**JEFFERSON MEMORIAL
NATIONAL MALL & MEMORIAL PARKS
WASHINGTON, DC**

CONTRACT # 1443C2000040800
REPAIR AND CONTROL SETTLEMENT AT JEFFERSON
MEMORIAL SEAWALL, NORTH PLAZA, AND TRANSITION
AREAS
PMIS NO. 128232

FINAL PREDESIGN DOCUMENTS

NATIONAL PARK SERVICE
DENVER SERVICE CENTER
March 6, 2008

FIGURE 9

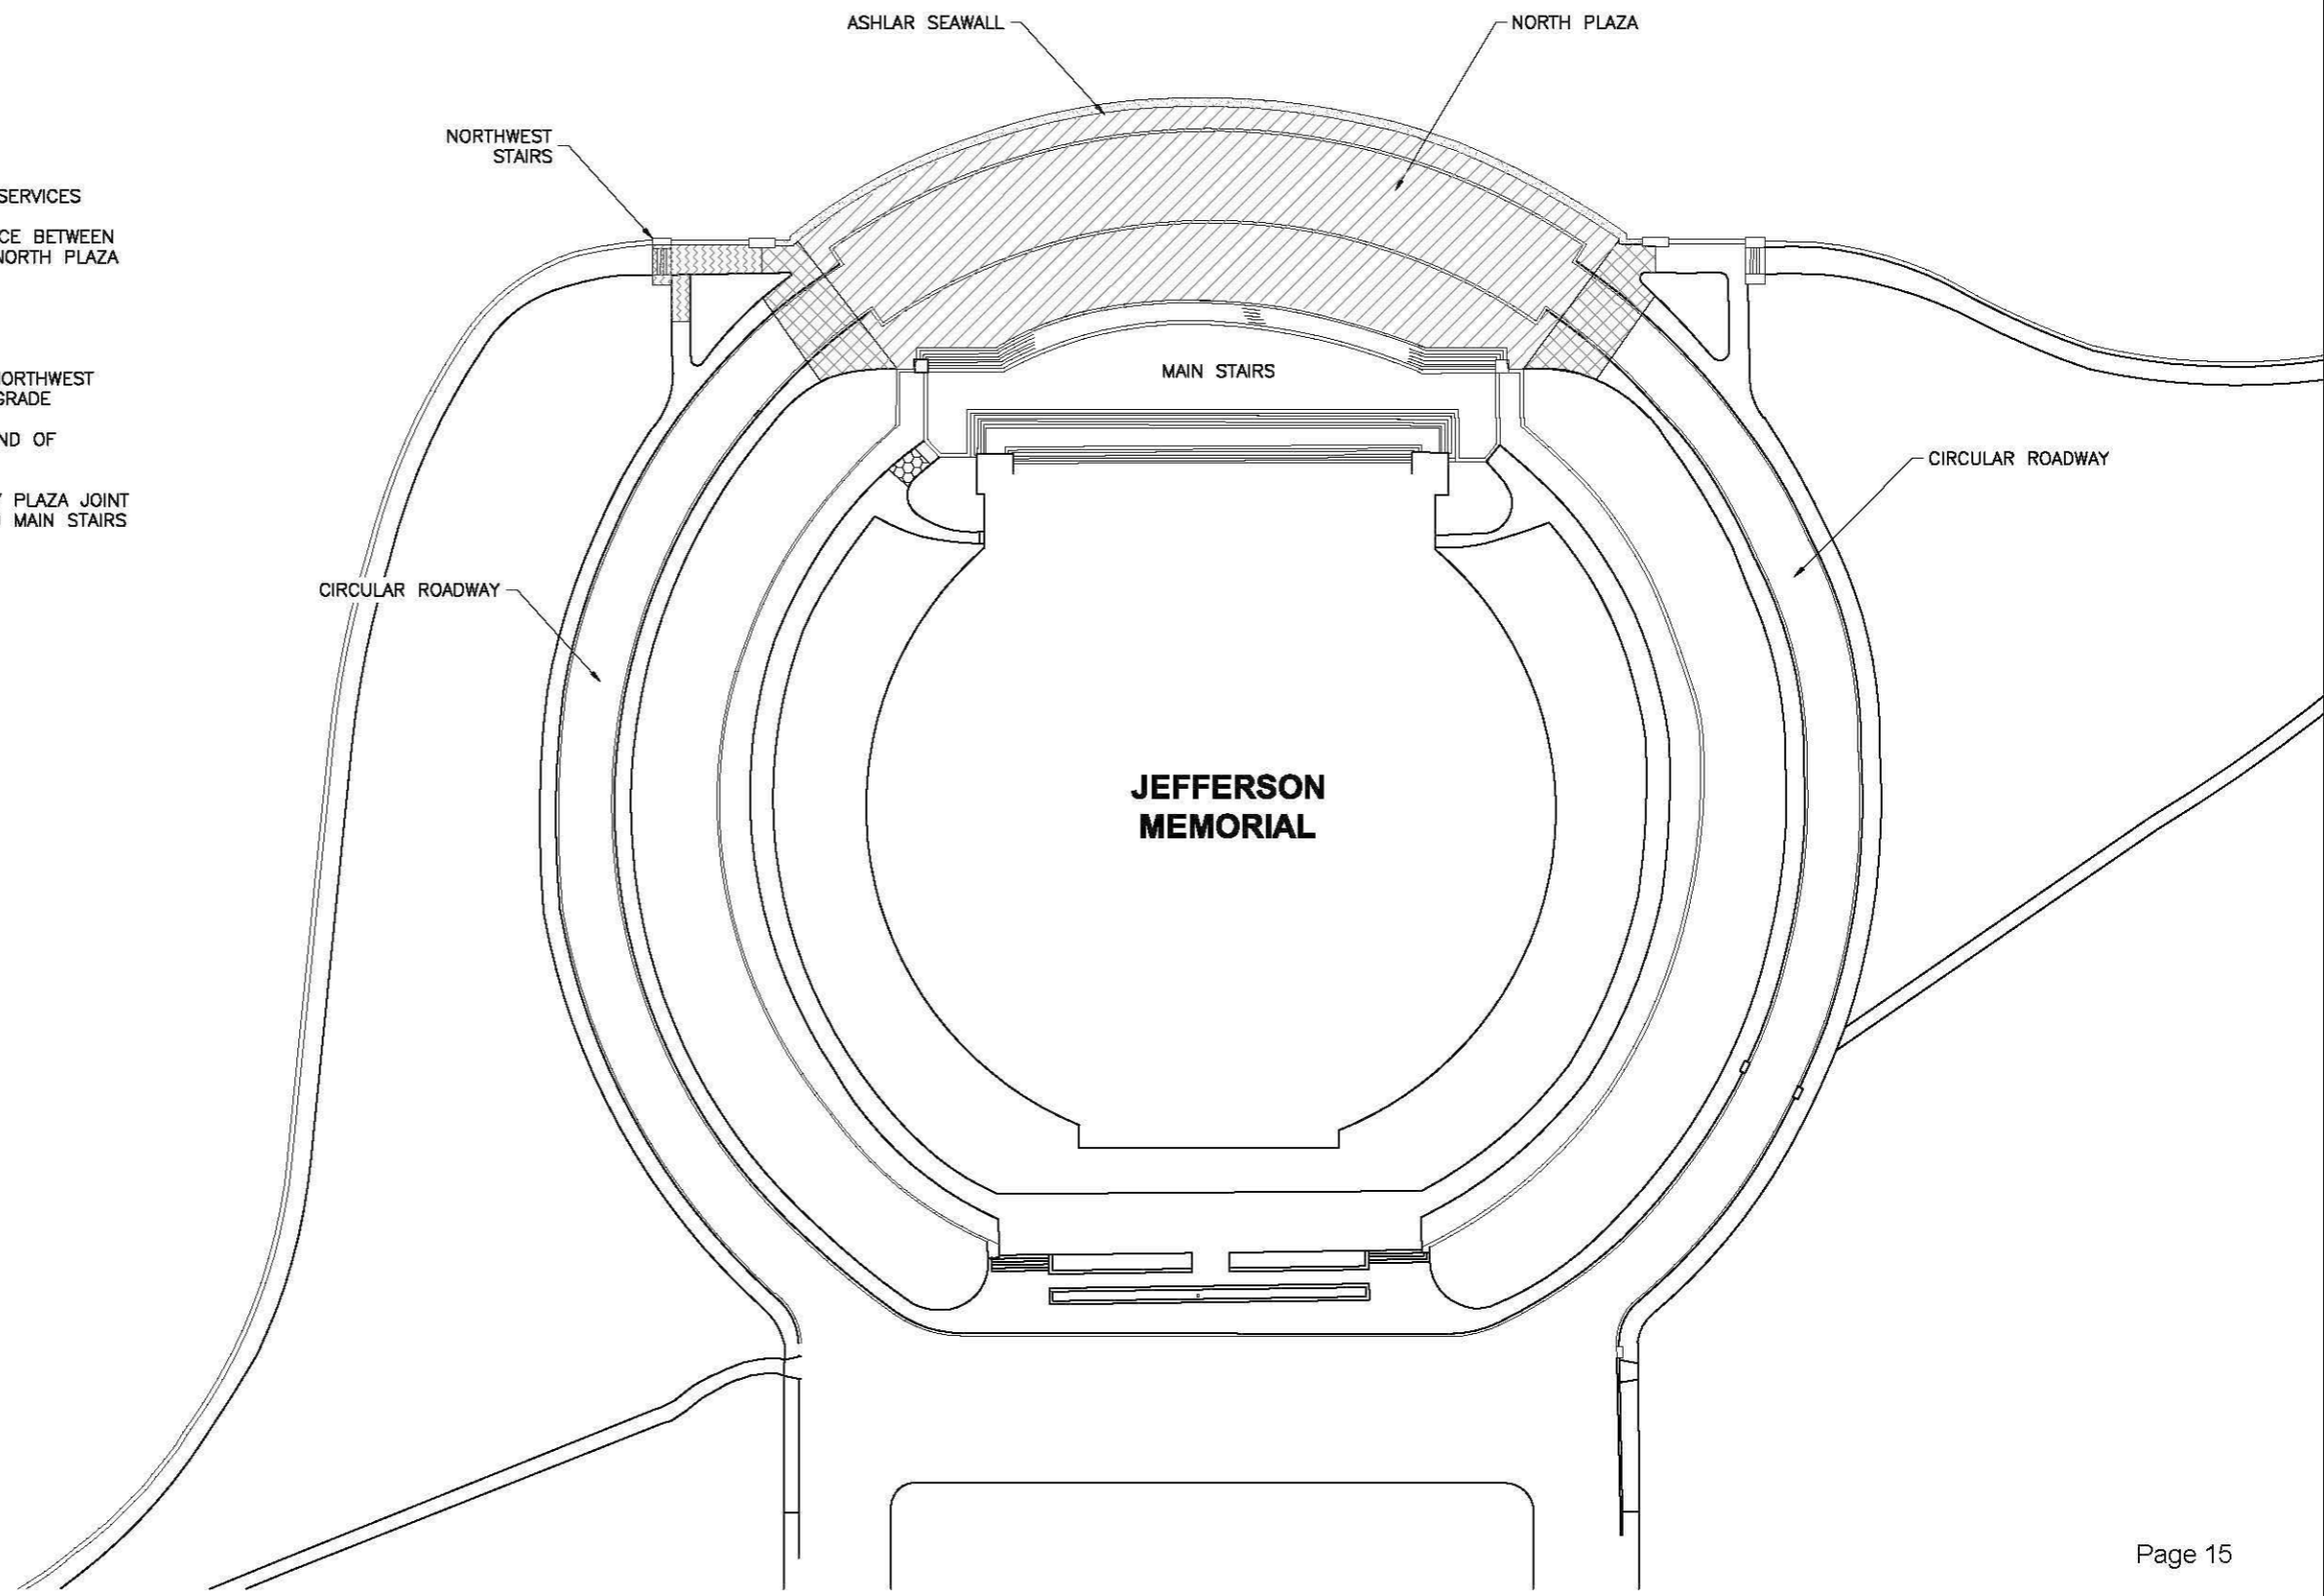
NO.	DWG or SPEC SECTION	QUALITY ASSURANCE COMMENT	RESPONSE
1	Page 15	Correct the scale of the legend hatching to the scale of the hatching on the drawing so they are the same.	This has been corrected. - SEI
2	Page 17	What is the basis for deciding which alternative to estimate? How does the NPS 'validate' the cost validation without a decision on which alternative to use?	[NPS DSC will address this comment. - NPS DSC D&C]
3	Page 18	Does the option chosen resist lateral movement?	The lateral movement is addressed through the alternative for the North Plaza remediation. - SEI
4	Page 20	How can we adjust the contracting method adjustment to reflect the NPS's plan? Is this project suitable for Design-Build?	Per NPS DSC, this is to be a "Full and Open" solicitation. - SEI
5	Page 23	Does the North Plaza option completely abandon the existing pile system? Is it necessary to install all new piles, caps and plaza? Aren't there soil anchoring methods that we could use with the existing foundation system to resist lateral movement?	The North Plaza option is a structural retrofit and supplements the existing pile system. For this option, new piles and grade beams are necessary, and their installation requires the removal and replacement of the North Plaza slab. Two additional remediation alternatives are being developed and include varying amounts of slab removal and replacement. - SEI

FIGURE 18

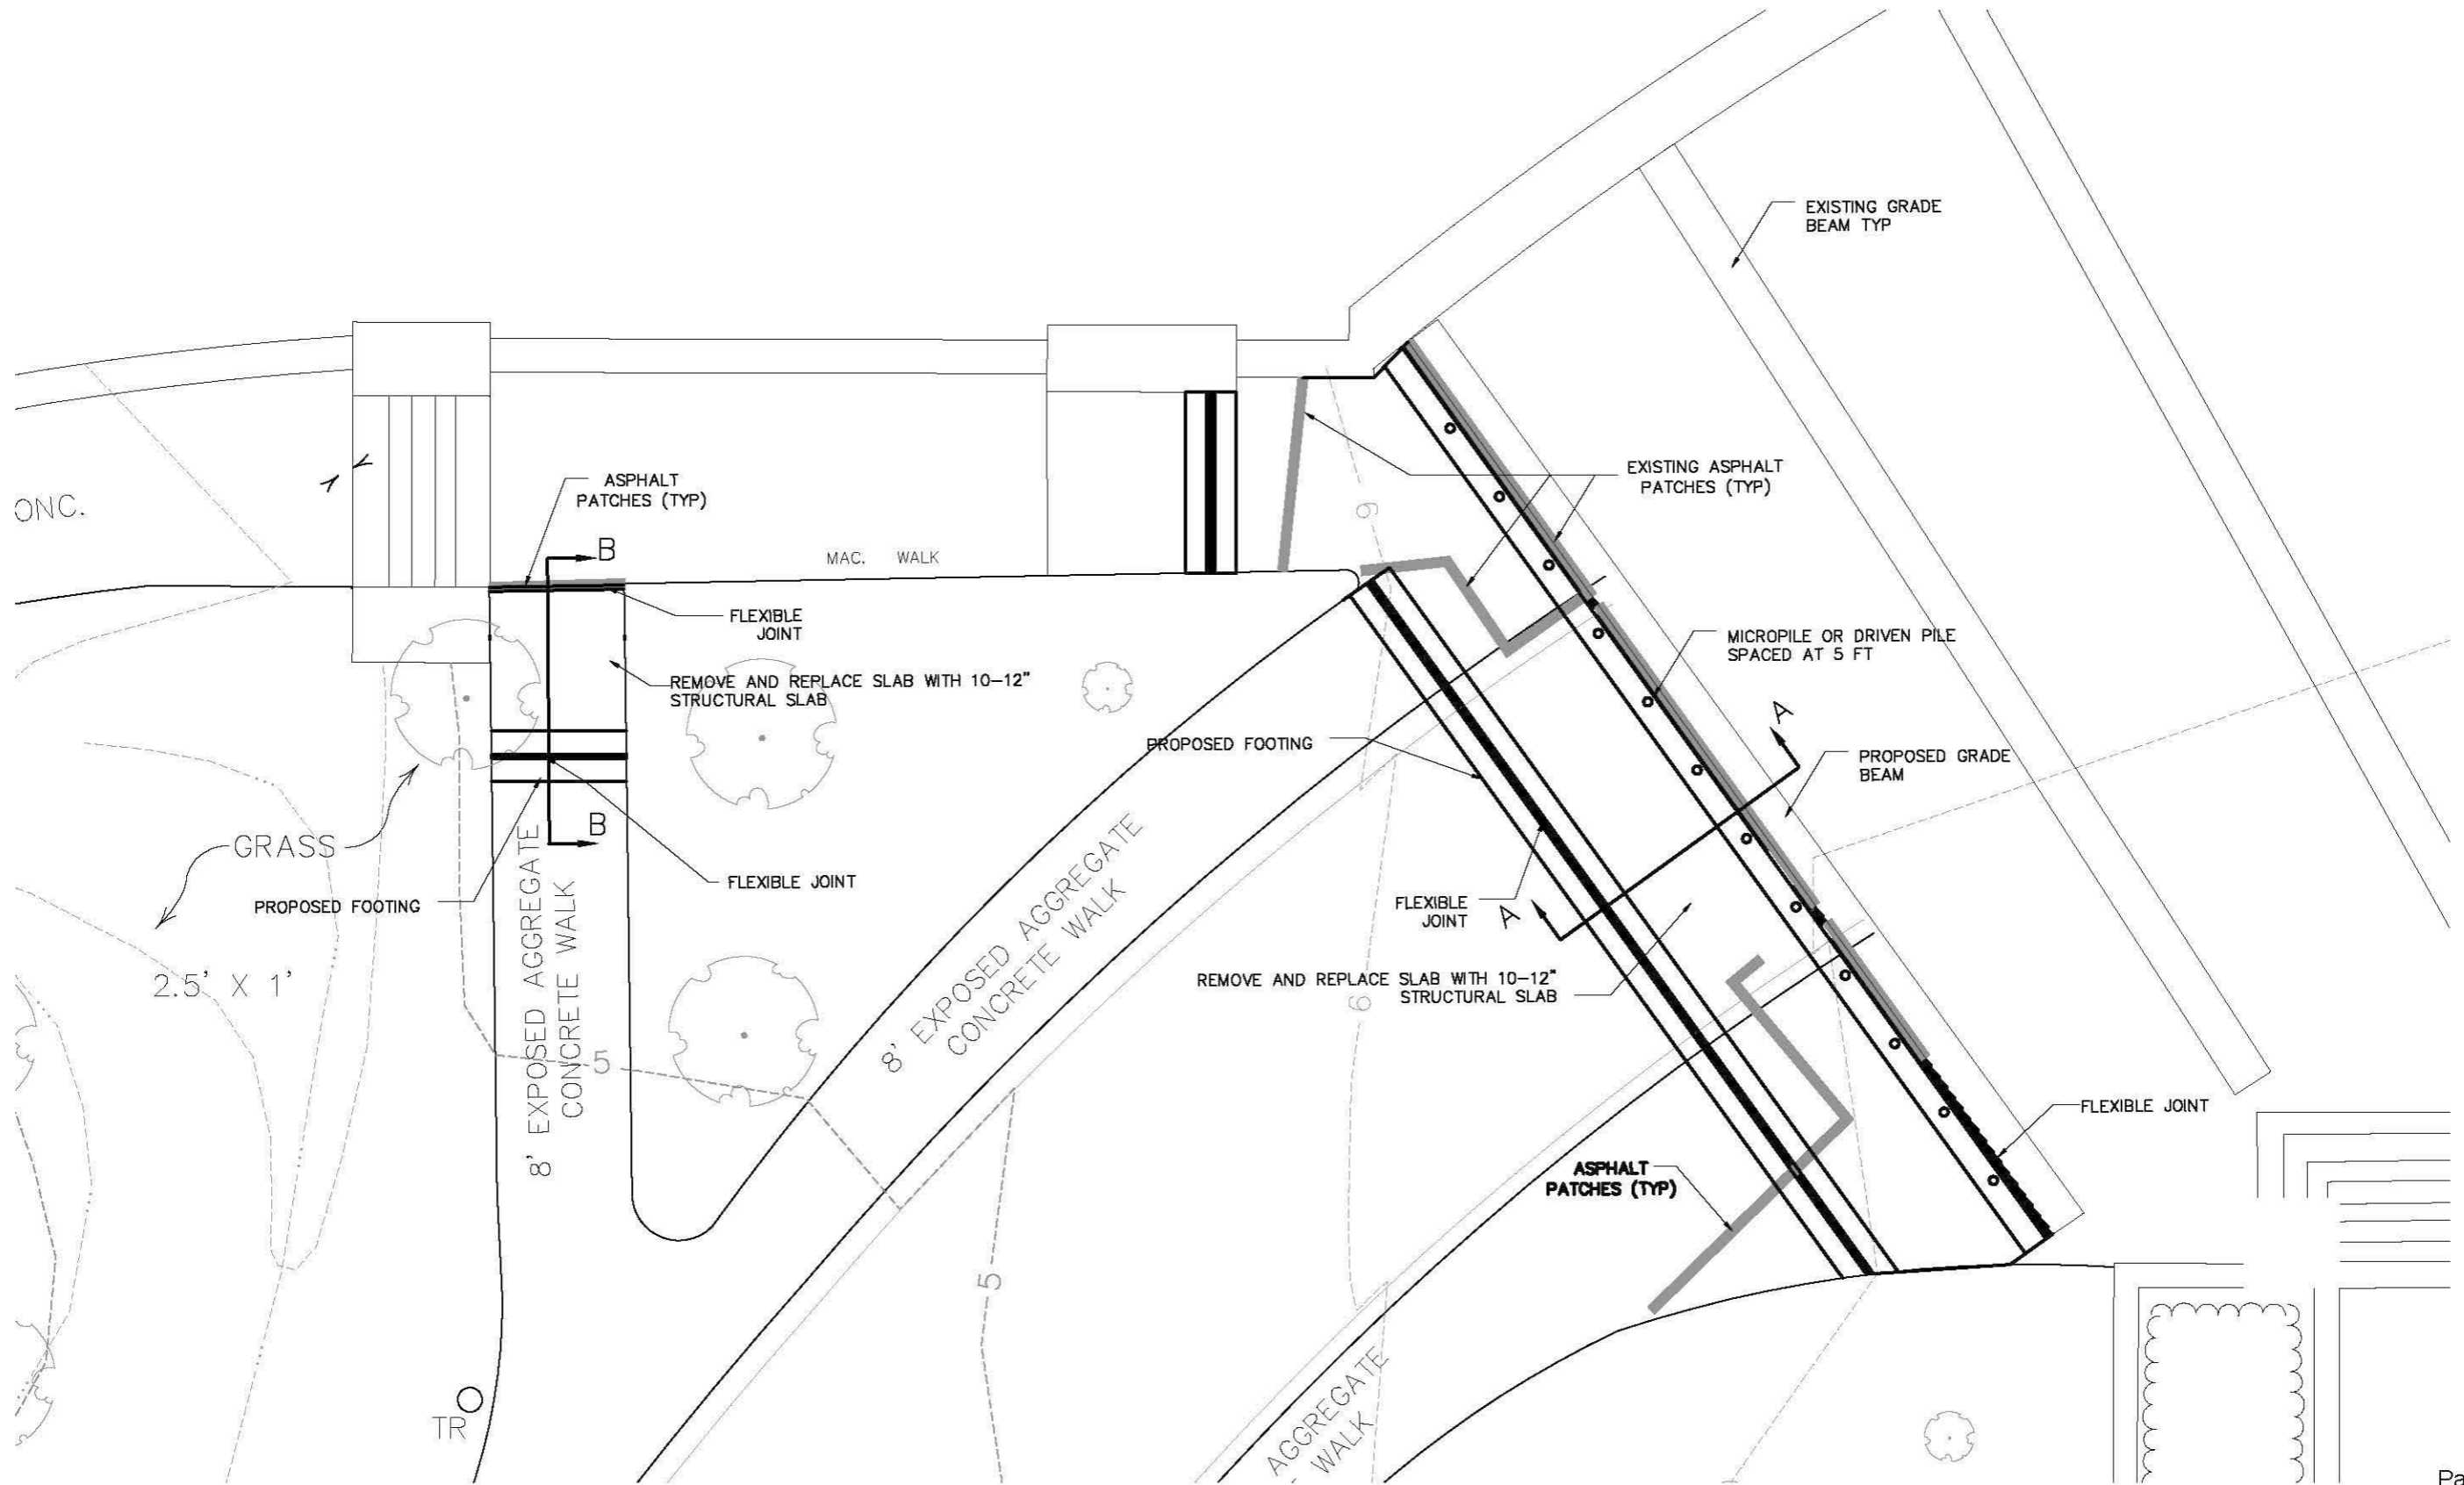
8	Page 34	How was the 10 foot dimension of the transition slab derived? Consider lengthening the transition slab to 20-30 feet with a few transition joints to allow more movement over a longer span.	This 10 foot dimension is a conceptual design and may be modified when the selected alternative is further developed. - SEI
9	Page 35	Can we re-use the existing pile cap instead of installing the micropiles and new pile cap?	The North Plaza alternative presented in the Predesign documents requires a new pile configuration and new pile caps. Other North Plaza alternatives consider the existing cap. - SEI
10	Page 37	Are the costs being used for the projects 'final' as-constructed costs? If not, shouldn't we compare the estimated cost of the Jefferson Memorial project with as-built cost data for an accurate comparison?	The information for "NJTA Pile Rehabilitation Maintenance" and "Children's Hospital Addition" shown in the Cost Comparability Analysis are as-built costs. The costs for "Ellis Island Seawall Repair" are as-bid. - SEI
